GENERAL APPLICATION

Location Address: **1817 TAYLOR STREET, HOLLYWOOD, FL 33020**

Explanation of Request: **FINAL TAC REVIEW**

Based on your TAC Comments dated December 5th, 2020 KEITH / BC Architects and the project team offer the following responses to your comments/questions:

SHEET NUMBER SP-101
PROJECT NUMBER 13778.00

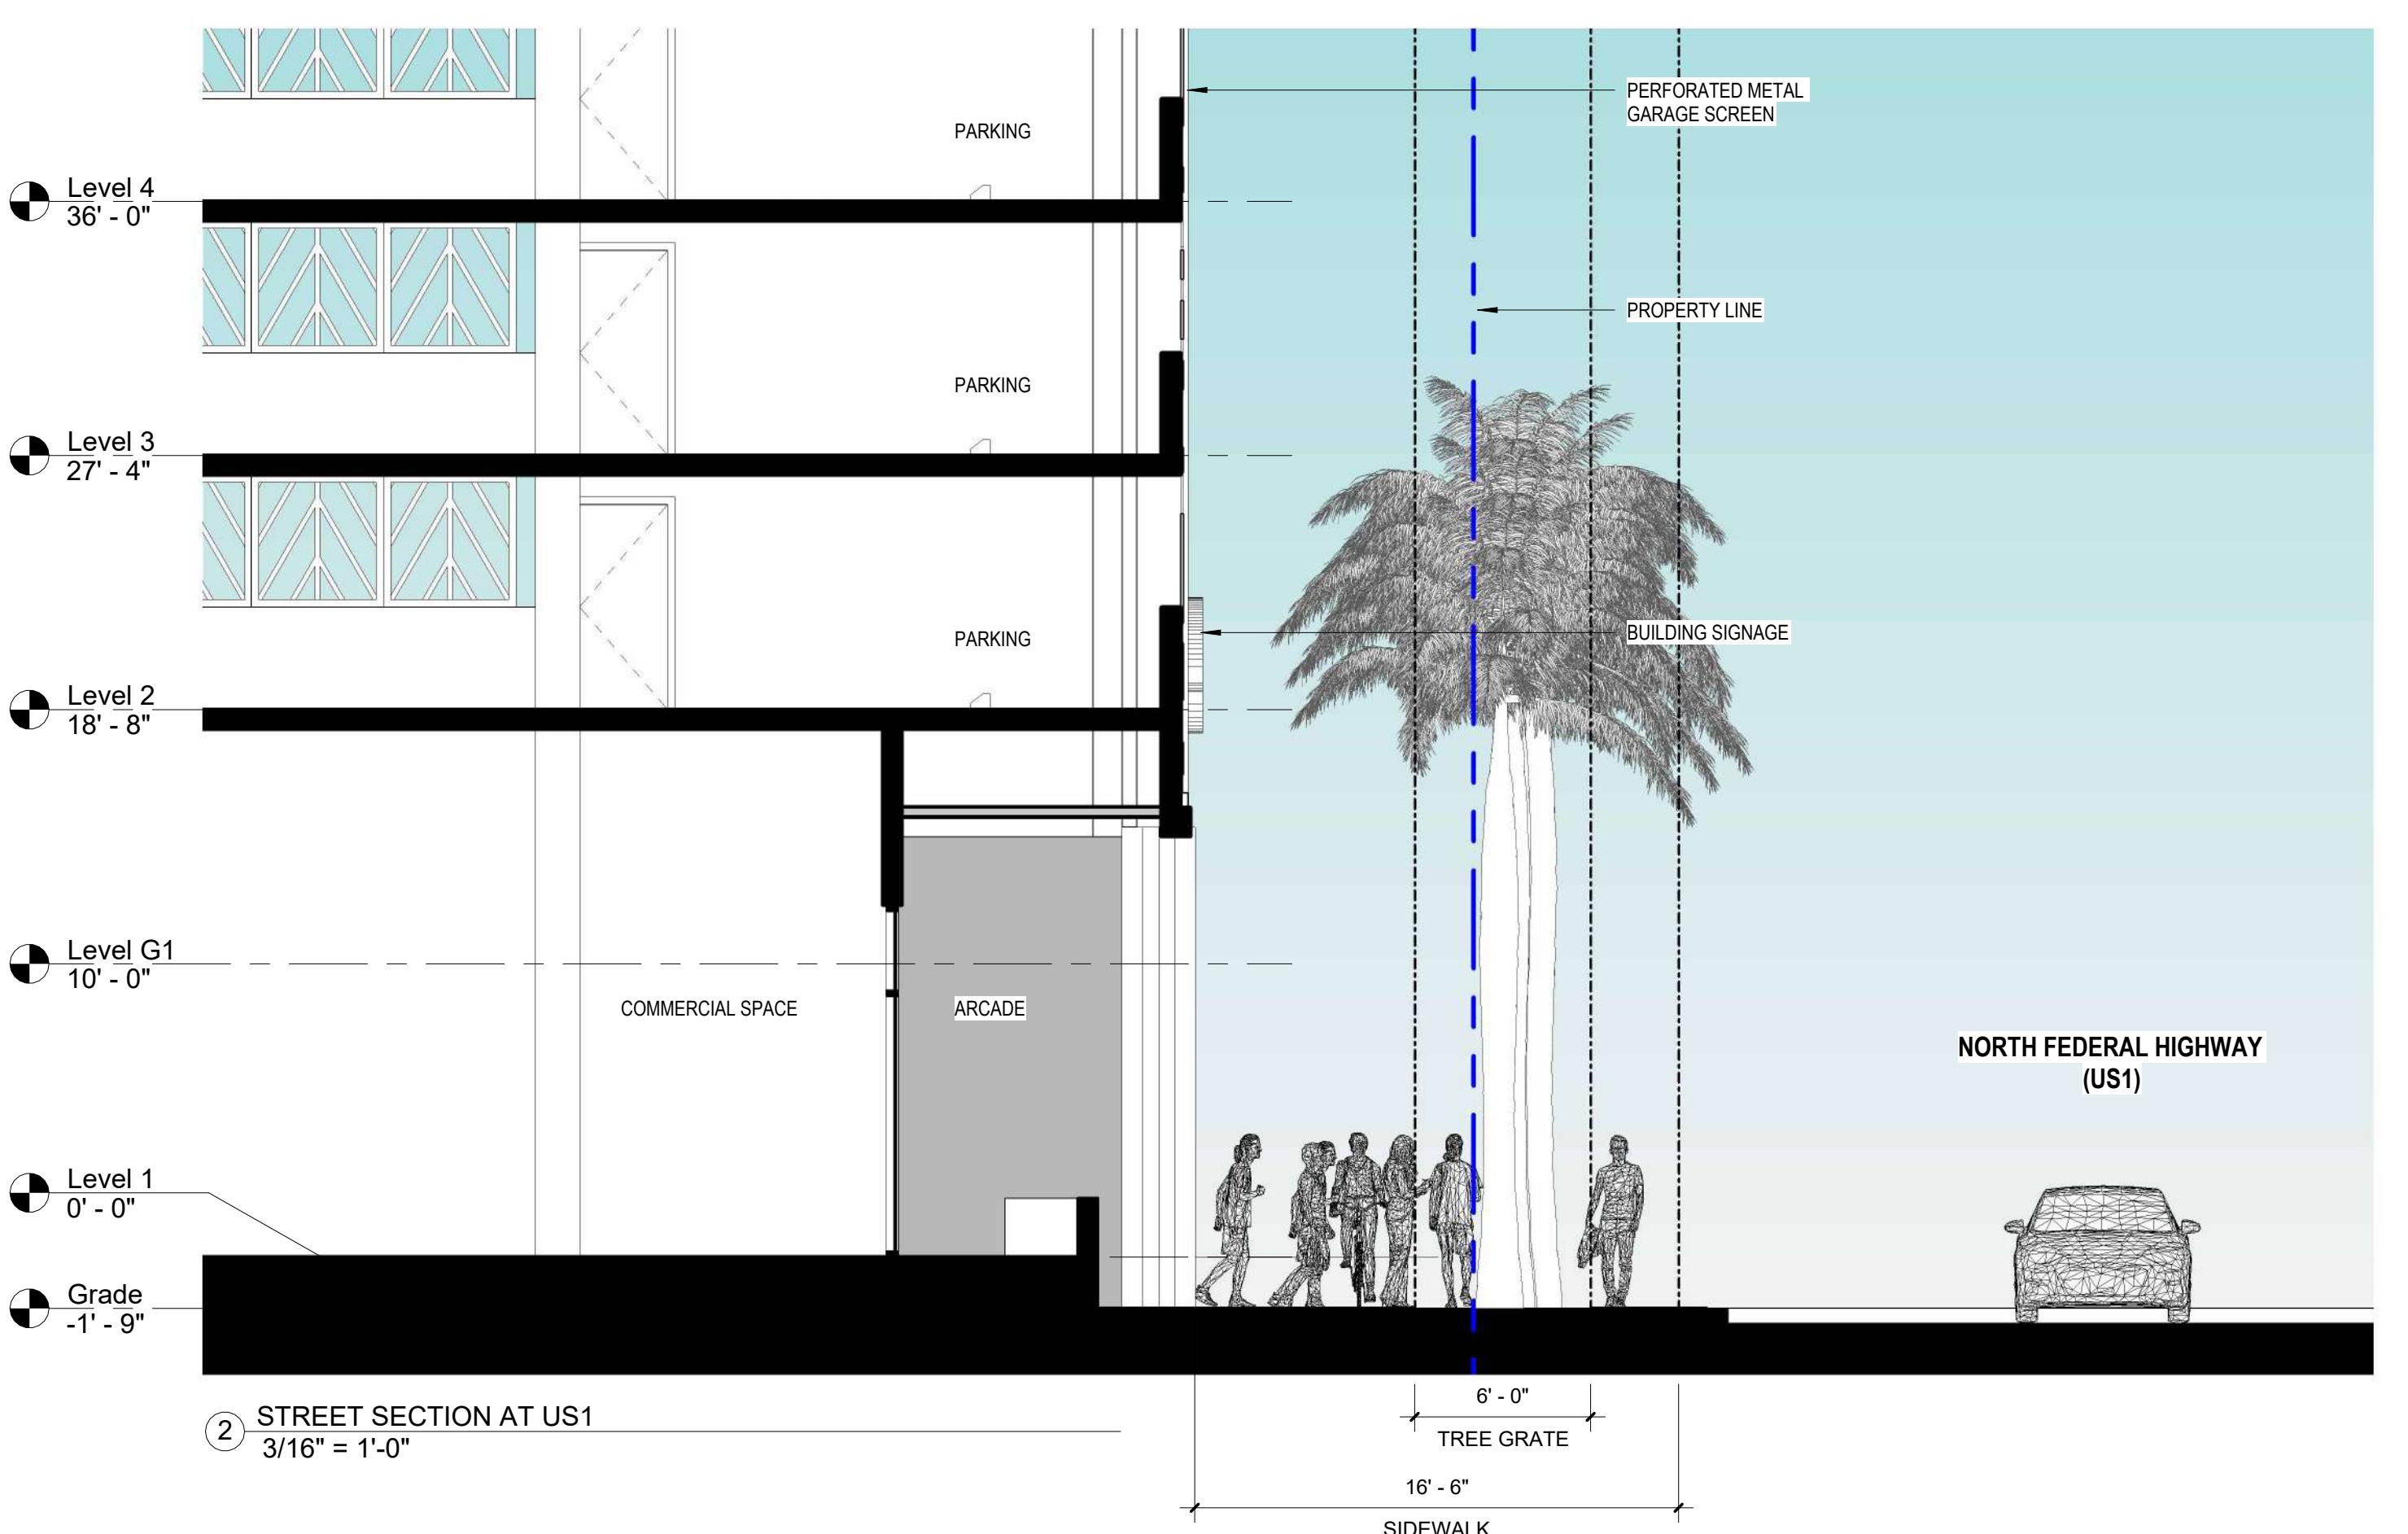
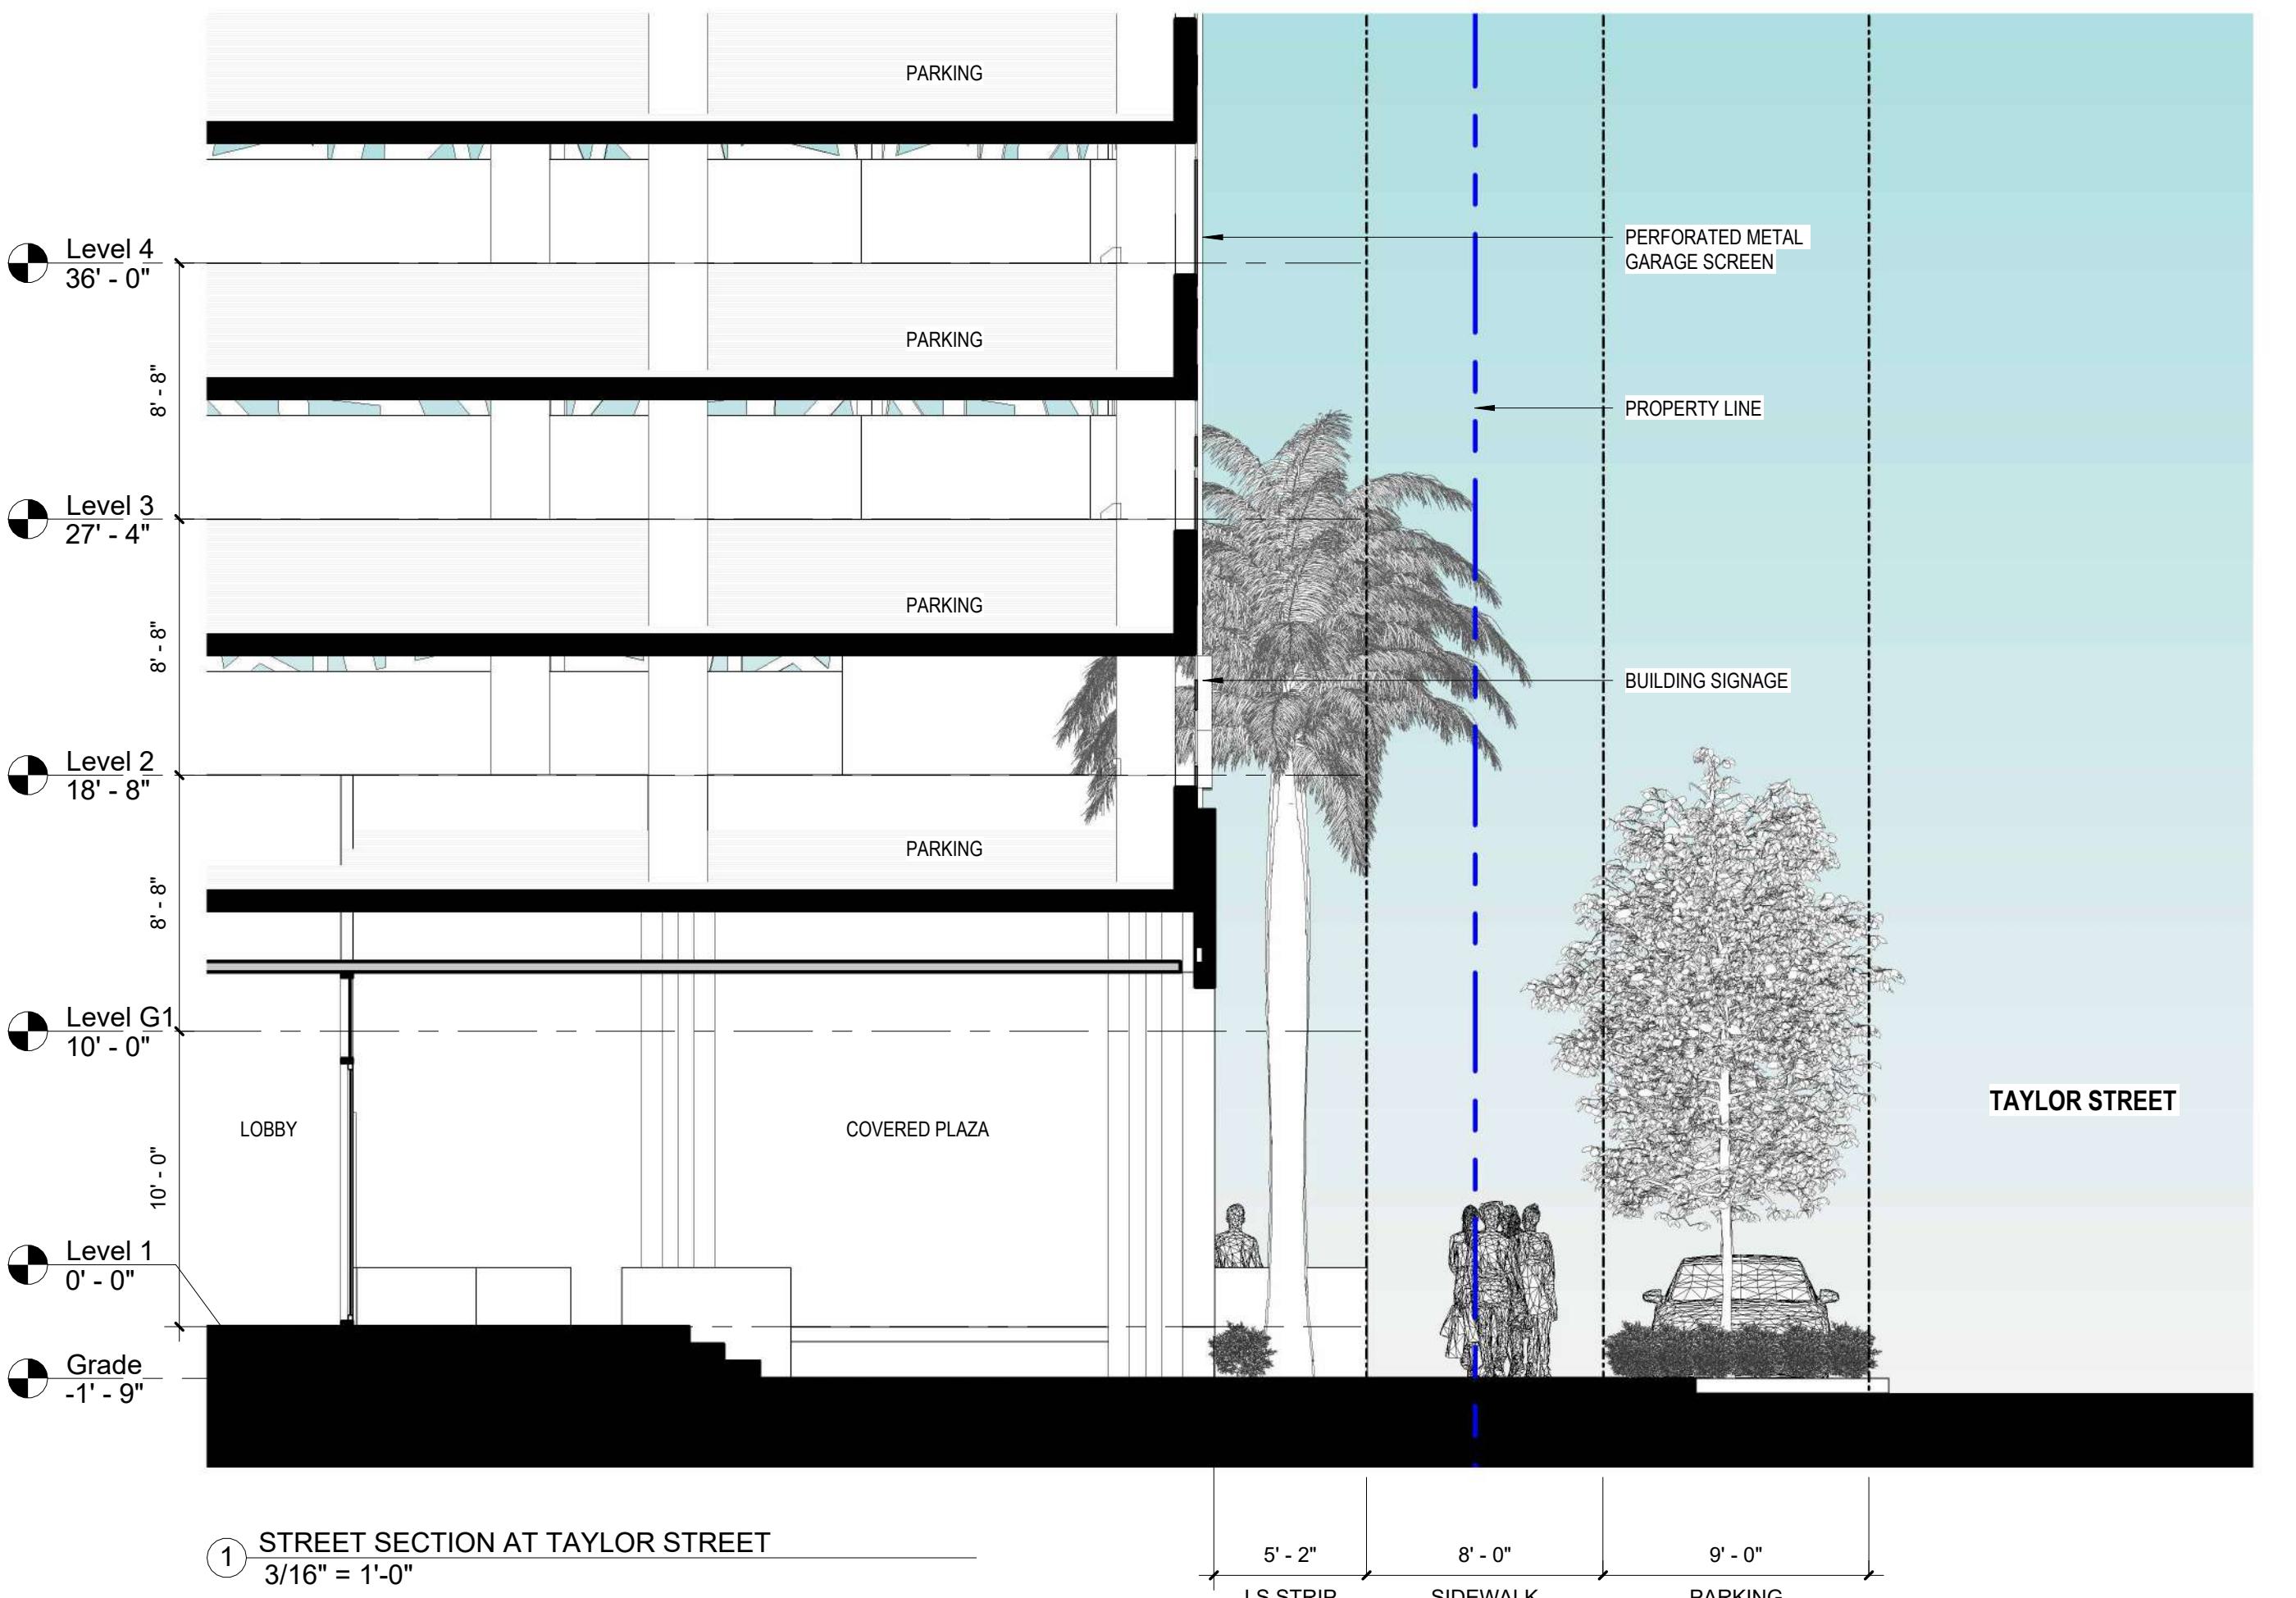
- a. Include note on Site Plan indicating that all changes to the design will require planning review and may be subject to Board approval.

- b. More clearly delineate the building footprint and any horizontal projections (e.g. balconies). As submitted the site plan provides details for roof level amenities that are confusing when reviewing overall building placement and setbacks on the property.

- c. West setback dimension on site plan needs to match the site data.

RESPONSE: Please refer to the new Site Plan, sheet SP-101 with added note as requested.

RESPONSE: Please refer to the new Site Plan, sheet SP-101 which has been revised and identifies building overhangs. Refer to Architectural floor plans which have also been revised.

RESPONSE: Please refer to the new Site Plan, sheet SP-101.
